Performance Monitoring Plan

Wagner Road Extraction

December 22, 2005

Pall Life Sciences
 Scio Twp., Washtenaw County, Michigan
 Wagner Road
 Performance Monitoring Plan

PROPOSED BORING/MONITORING WELL LOCATIONS

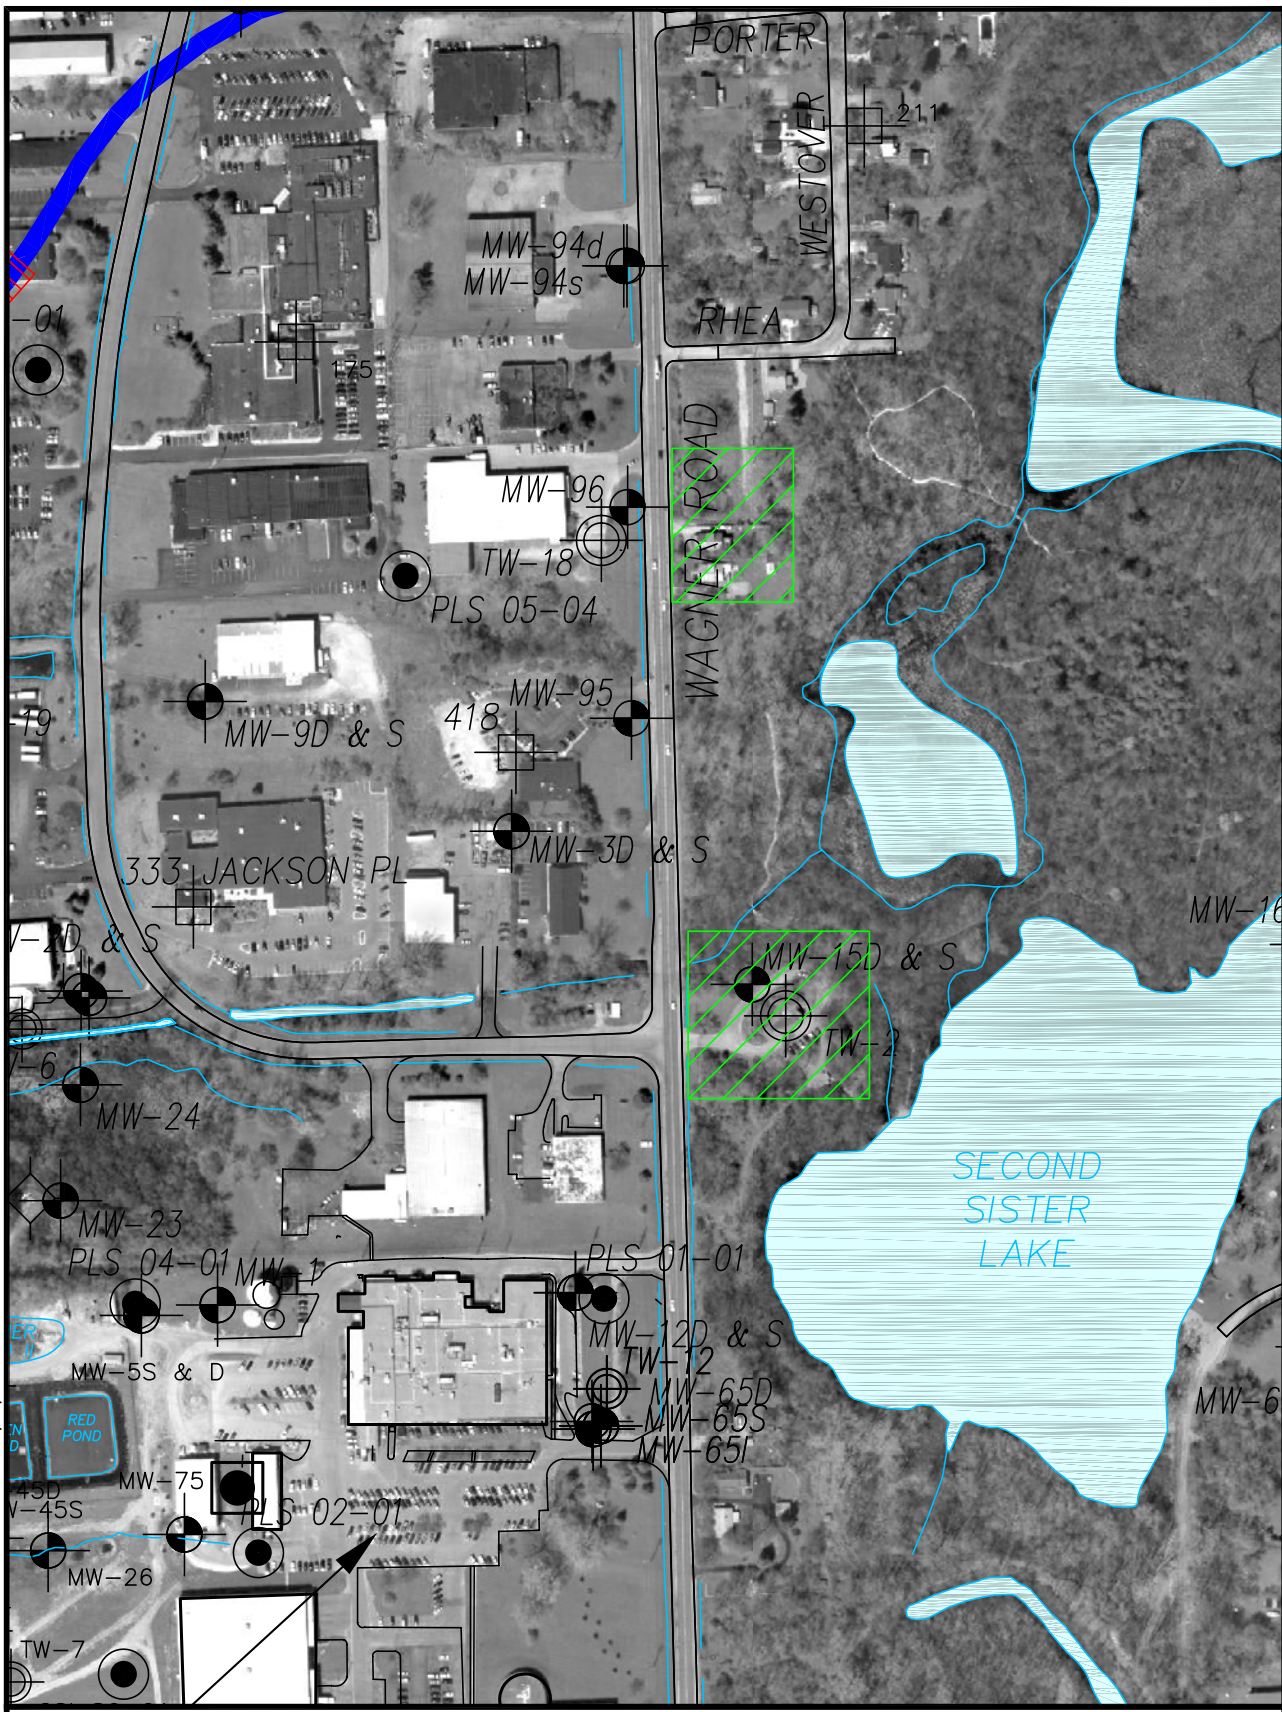
MDEQ has commented there is a potential Groundwater Surfacewater Interface (GSI) concern related to the Unit E plume and First/Second Sister Lakes. Data collected by PLS

MDEQ has questioned PLS's interpretation of the southern boundary of the Unit E plume, specifically the area between TW-18 and TW-12. PLS has proposed to investigate this area to further the understanding of the Unit E plume in this area.

PLS proposes to install one or more wells at two locations. One well, positioned east/northwest of TW-18, will be installed as a performance monitoring well. A second well, south of TW-18, will be installed to further investigate the extent of 1,4-dioxane south of TW-18. . Proposed areas for the installation of these wells are shown on Attachment 2 and are described below.

PLS is proposing the installation of a well(s) in the area shown on Attachment 2. Data from this boring/well(s) will be used to assess conditions in this area and to evaluate the potential need for adjustments to the purge system.
